**Letter of Map Revision  
For the Morris Property  
APN 503-86-007X**

**Circle City Wash 1  
RM 0.000 to 0.344**

**Subject:** Morris LOMR Request and Technical Data Notebook, Contract FCD 2011C002 – WA #2

**Subject: Morris FPAP Revised Draft Hydraulics Analysis and TDN dated August 2011**

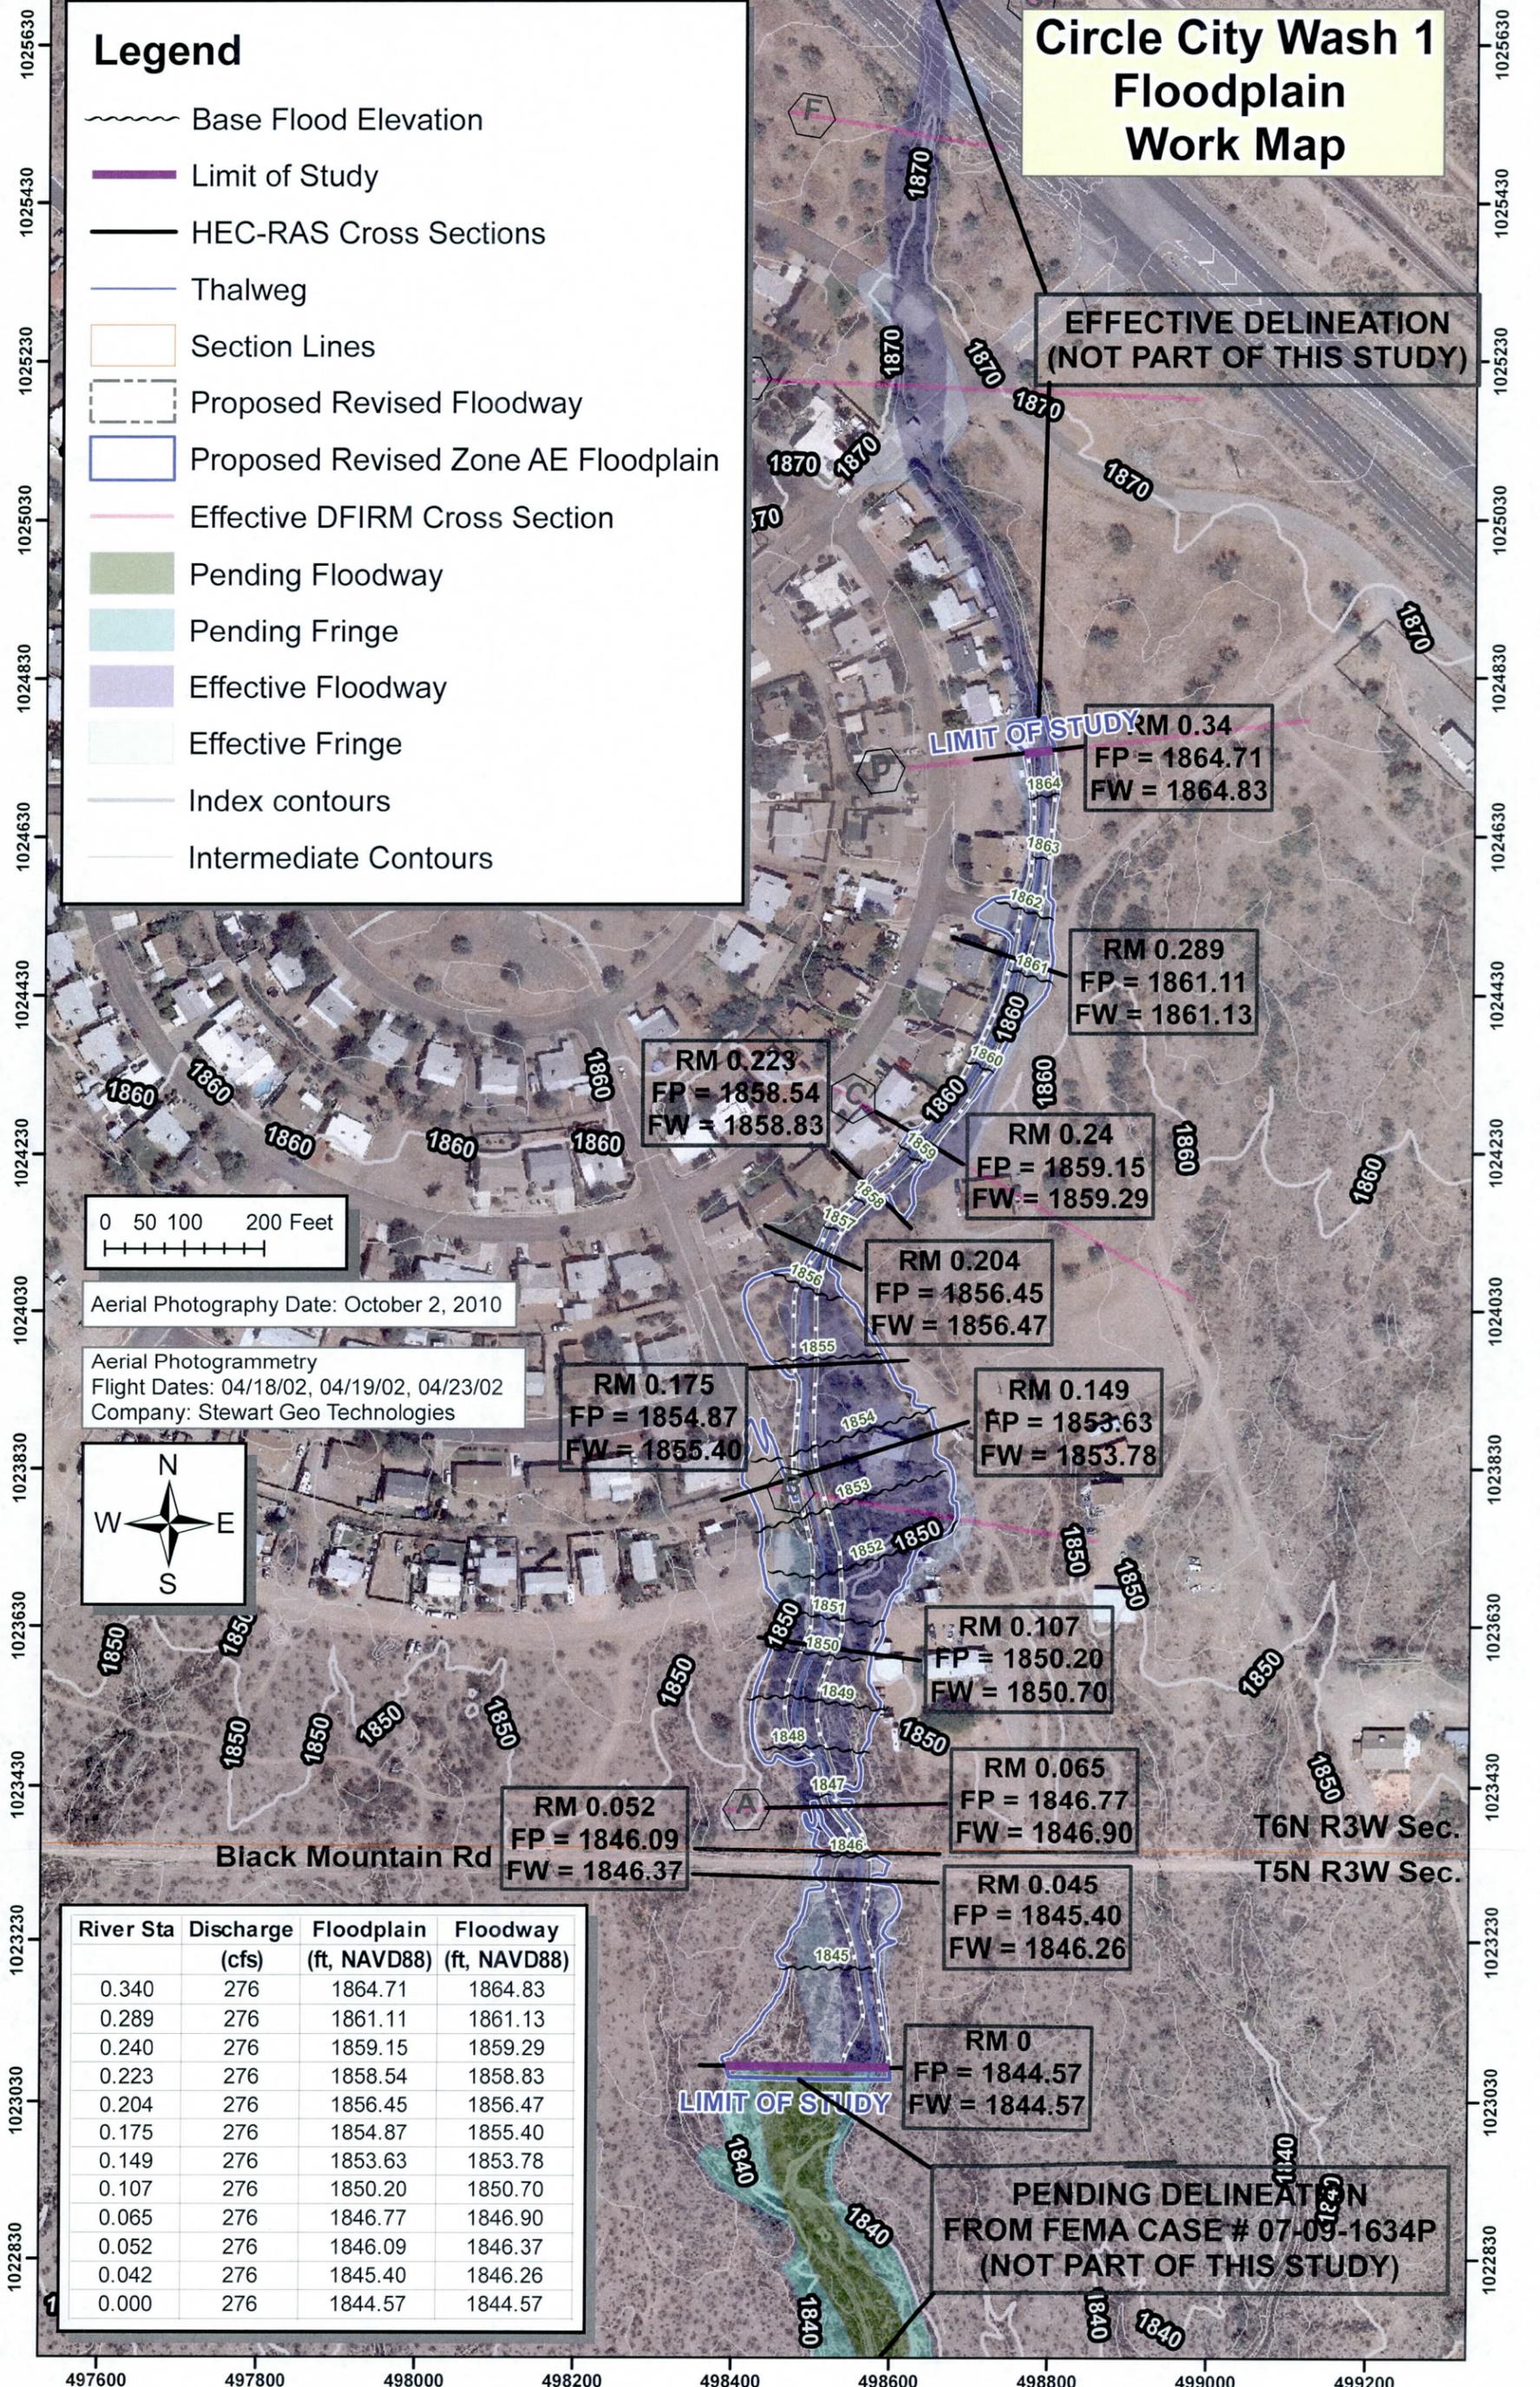
Please provide revisions to the Study Map as follows:

- A. The effective zones, such as above FEMA cross section "D" should be grayed-out or lightened otherwise, with the note callout added: "(not part of this study)".
- B. The pending effective zones, such as below the downstream limit of study, should be grayed-out or lightened otherwise, with the note callout added: "(not part of this study)".
- C. I suggest adding the word "Effective" in front of DFIRM Cross Section in the legend.
- D. Please make the cross section halo-ing either transparent or eliminate it. The idea is to not cover anything up, if possible.

- A. Please show the pending FP below cross section RM 0.00 because details of the tie-in should be shown. Please show the pending FP as grayed-out and labeled "(not part of this study)". Labeling the FEMA case number for the Entellus' study would be a nice touch. The FEMA case number was 07-09-1634P.

- B. Please do not show any revisions (proposed FP/FW) below the last cross section RM 0.00. This means the Limit of Study Line must be exactly at the cross section

- C. Please add and specify the Pending Floodplain Zones to cover the WLB study information.

*JEF Response: JE Fuller has included the pending floodplain/floodway information from the Entellus study to the reach adjoining the study reach in the downstream end. The pending floodplain/floodway information has been provided using reduced transparency level to obtain the "grayed-out" effect. A label, identifying the delineation as pending with FEMA case number, with a callout pointing to the pending reach has been added to the workmap.*

*JEF Response: JE Fuller has moved the "LIMIT OF STUDY" to cross-section 0.00. A graphical floodplain tie-in is displayed downstream of RM 0.00 to provide appropriate horizontal tie-in to effective floodplain.*

*JEF Response: JE Fuller has added the grayed-out pending floodplain and floodway to the map for the reach adjoining the study reach at the downstream end of the study reach. The map legend has been updated to show the pending delineations. The grayed-out effective floodplain is shown in the background of the study reach as well as in the reach adjoining the study reach at the upstream end. The map legend has been updated to identify the grayed-out effective delineations.*

Morris LOMR Plan: Final Draft 9/14/2011  
 River = CCWash1 Reach = Morris RS = 0.065

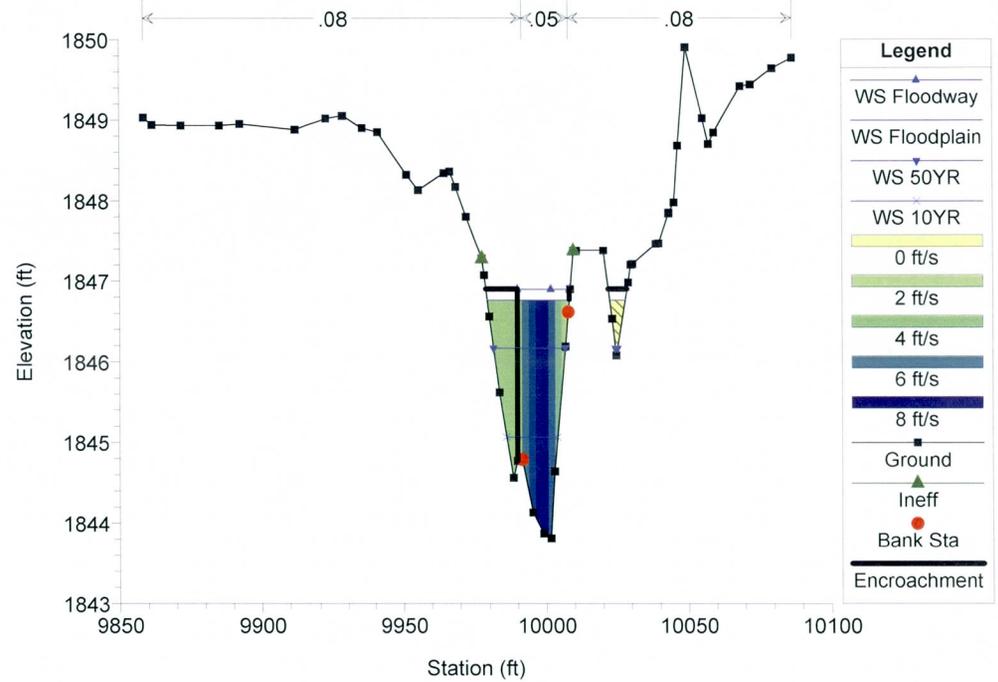
An ineffective flow area should be added to the right-hand side of modeled cross section 0.065 near station 160. Please address.

*The ineffective flow area will be added as suggested*
